PC 24-05

Amend approvals previously granted for the subject property to allow construction of a two-story multi-tenant commercial building with drive-through; approval of a plat of subdivision.

Anna Papke, AICP
 Planning and Zoning Manager

SUBJECT: Site Plan Evaluation
Proposed Creekside Plaza
Lombard, Illinois

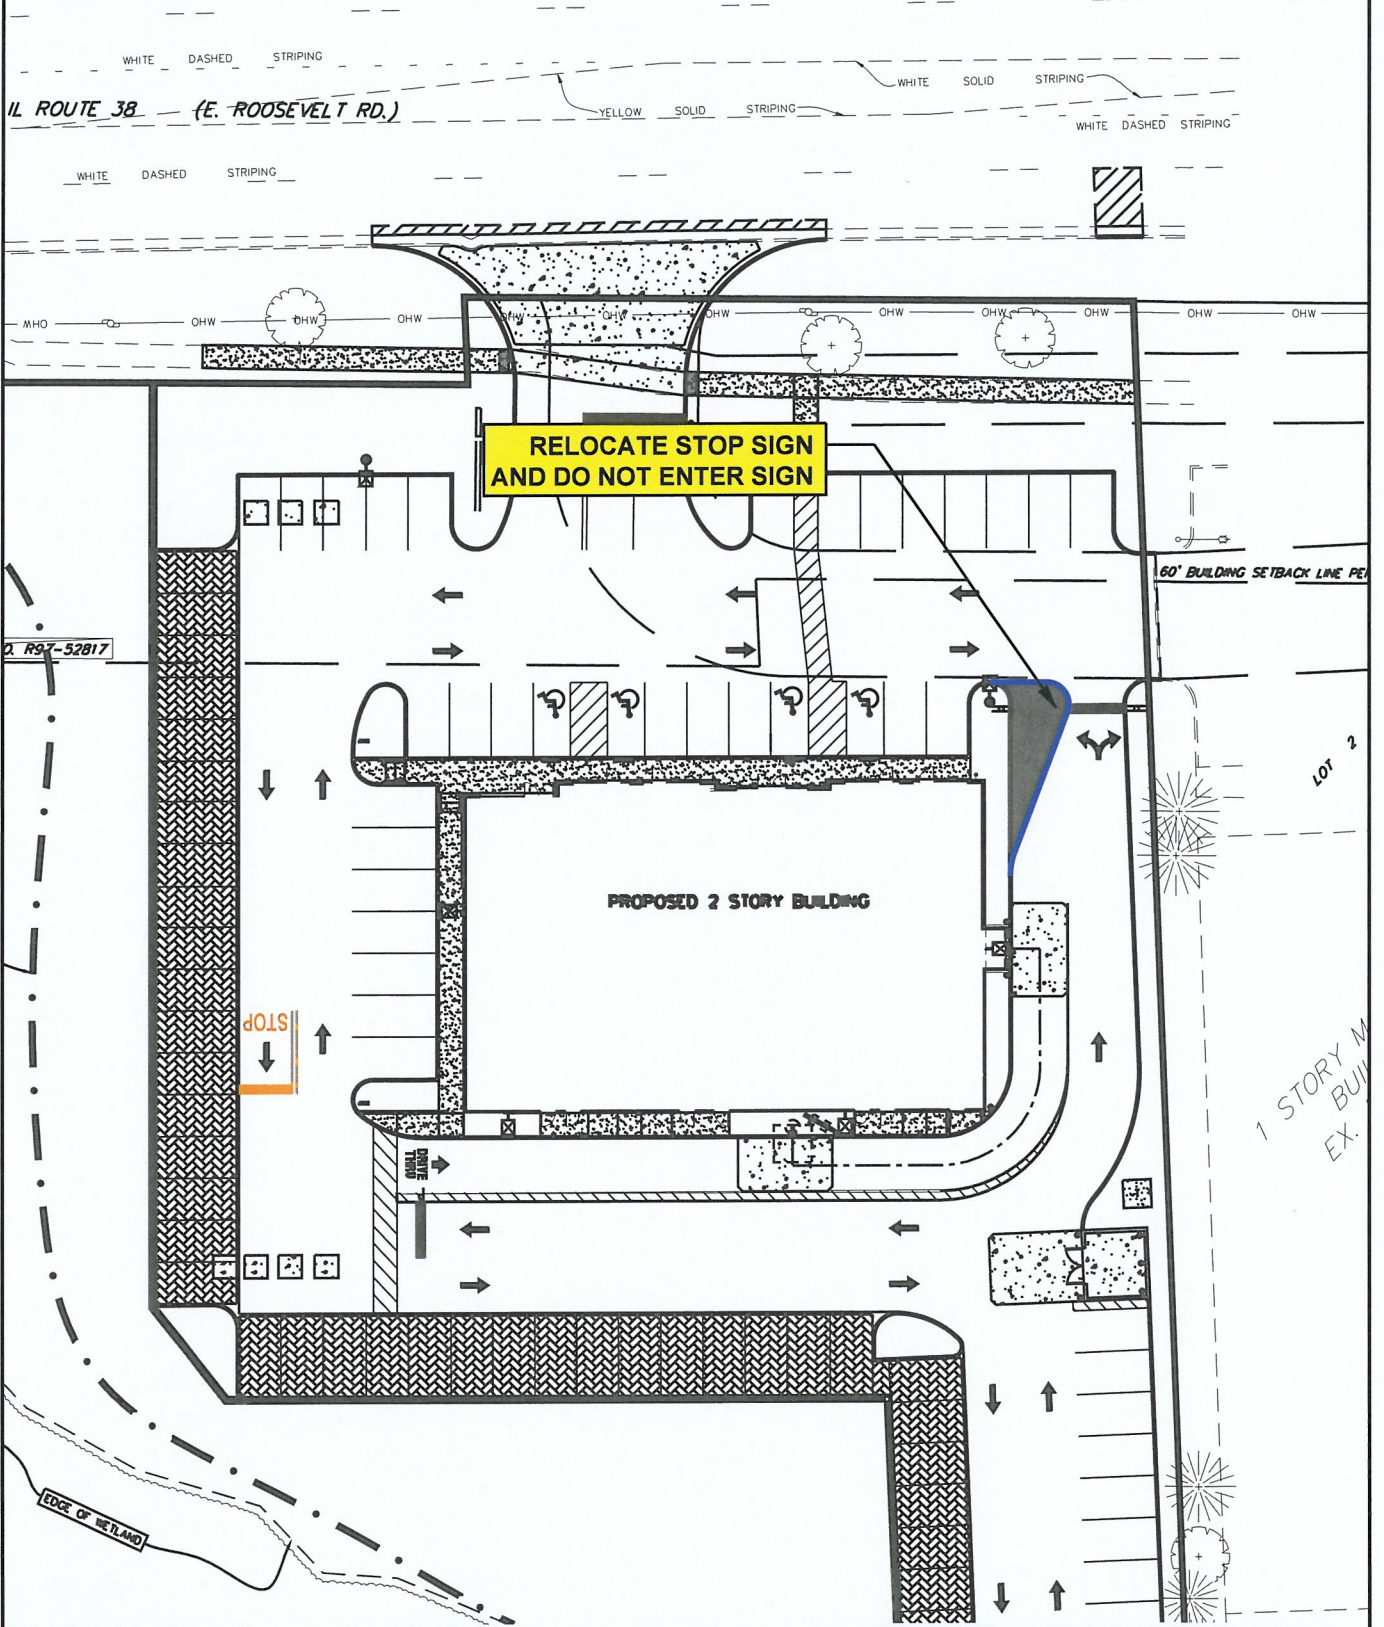
The drive-through lane, as proposed, will serve the proposed coffee shop and will have a counterclockwise flow with vehicles traveling east to north on the south and east sides of the building. The current site plan shows that approximately four vehicles can stack from the pick-up window to the ordering board and another four vehicles can stack from the ordering board to the beginning of the drive-through lane for a total stacking of eight vehicles. Based on KLOA, Inc.'s observations in the morning peak hour of a coffee shop in Lombard, the maximum observed queue was five vehicles and the average was three. Additional observations by KLOA, Inc. at other coffee shops have indicated a maximum queue of eight vehicles with an average queue of six vehicles. As such, the stacking capacity provided for this facility will be sufficient to accommodate the peak drive-through demand and the vehicle queues at the drive-through facility.

The development as proposed will provide, at a minimum, 24-foot-wide drive aisles within the parking lot, allowing for efficient circulation. Based on a review of the site plan, the southern drive aisle will run parallel with the drive-through lane. In order to control and organize the turning movements that will occur on the southwest corner of the building, it is recommended that a stop bar be painted on the western drive aisle for southbound traffic. This stop bar should be located approximately 12 to 14 feet north of the drive-through lane entrance. Further inspection of the site plan indicates that the east side of the building will have two northbound lanes intersecting the northern east-west drive aisle. One lane will be the exit lane of the drive-through facility while the other lane will be the by-pass lane. This exiting drive from the facility should be narrowed down to one lane in order to control the exit flow and provide a better radius/curvature for vehicles desiring to turn left and exit via the full access drive. The outbound movement should be under stop sign control and a "Do Not Enter" sign should be posted on the exit drive facing north. Exhibit A in the Appendix illustrates the recommended modifications.

- The two exiting lanes on the east side of the building should be narrowed down to one lane in order to control the exit flow and provide a better radius/curvature for vehicles desiring to turn left and exit via the full access drive.
